**Technical Evaluation Report for Derived Concentration Guideline Level
Supporting a License Amendment Request for
Release of Room 101, Building 4707, Marshall Space Flight Center
National Aeronautics and Space Administration**

Figure 1 Percent contributions of uranium isotopes to total activity as a function of uranium enrichment by gaseous diffusion (adapted from DOE-STD-1136-2000, Figure 2-2)

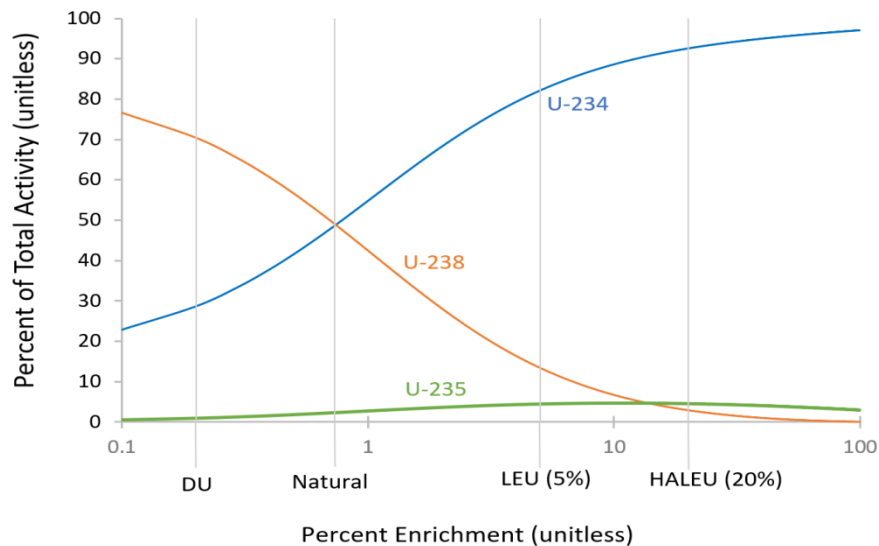
That calculation resulted in relative activities of 92.5% U-234, 4.62% U-235, and 2.97% U-238. Repeating that calculation for values of E from 0 to 100 result in Figure 1 (below), in agreement with DOE-STD-1136-2000, Figure 2-2.
